APPENDIX B – Residents and Submissions on behalf of Individuals

This document summarises and provides a response to the 234 submissions received from 232 residents and individuals in response to the exhibition of the Parramatta CBD Planning Proposal. Each submission has been allocated a unique number according to the date the submission was received by Council, for example, “Submission Number 1”, also sometimes referred to as “Submission 1”.

Figure – Height of Building Map for 7, 9 Marion and 64 High Streets

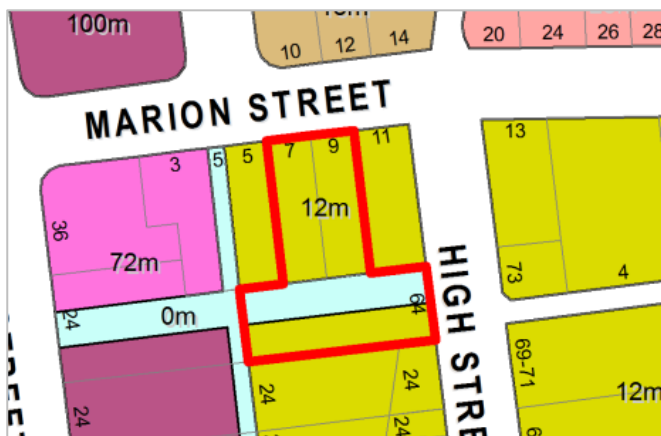
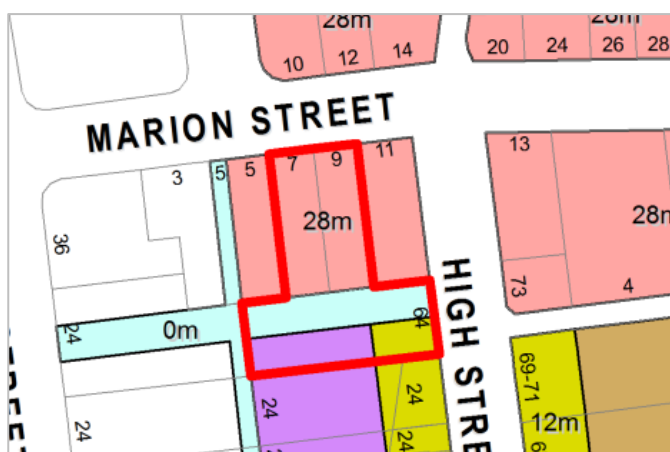
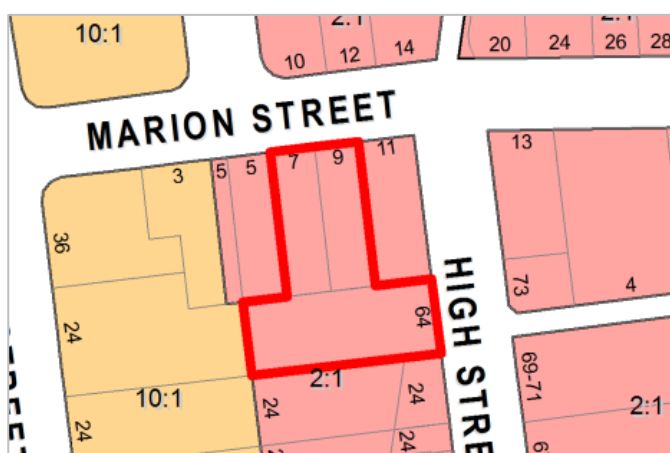
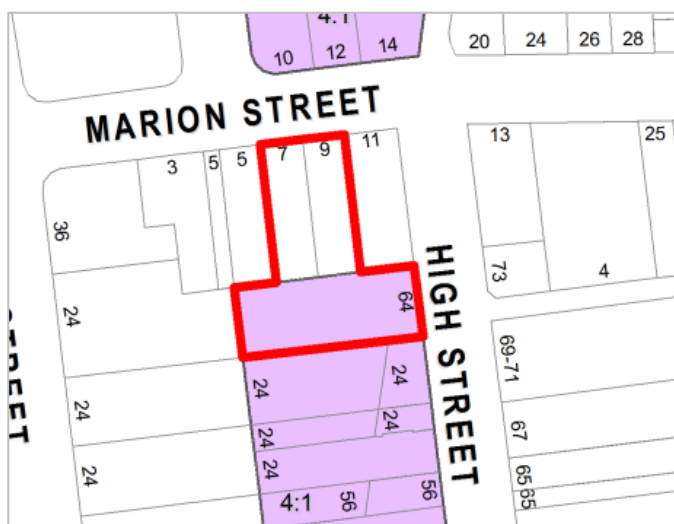
- The 0 metre incentive height notation over part of 64 High Street and a 4:1 incentive FSR over the entire site means landowners do not have to forego FSR as it encourages dedication of part of the site for the purposes of a laneway. The submitter's proposed changes would require amendments to sub-clauses 7.2(1) and (2), the Incentive HOB map and the Incentive FSR map.

The exhibited height and FSR controls which are lower than those in the central CBD location respond to the distance from the CBD core. Furthermore, the *Marion Street Precinct Heritage Study* prepared by SJB (2019) reduced the building height from unlimited building height to 28 metres. This is the primary study for informing proposed controls in this precinct along Marion Street.

Figure – 328 Church Street and LRA notation extent

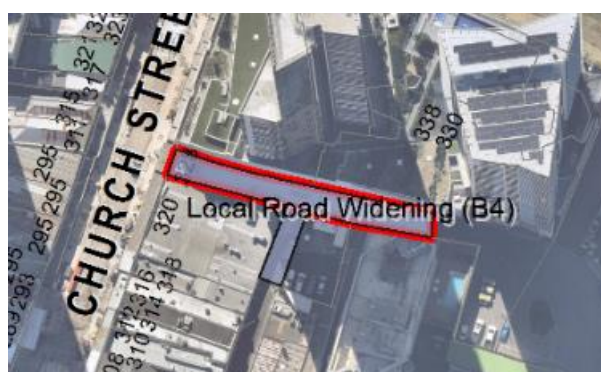
- This submission was prepared by Mecone on behalf of the landowner (Two-Dad Pty Ltd) of 328 Church Street, Parramatta. (Note: a second, follow up submission replaced an initial submission). The El Phoenician Restaurant is currently situated on this site.
- The existing major (PLEP 2011) controls for the land are: B4 Mixed Use zone; part 12 metre and part 80 metre building height; 6:1 FSR; and ‘Local Road Widening’ (B4) notation on the LRA Map (blue notation) affecting the entire site for the purposes of a 6 metre wide laneway. Refer to the area bound red in the figure below.

- The landowner requests the removal of the existing ‘Local Road Widening (B4)’ on the LRA Map affecting the entire site for the laneway to provide certainty for the landowner.
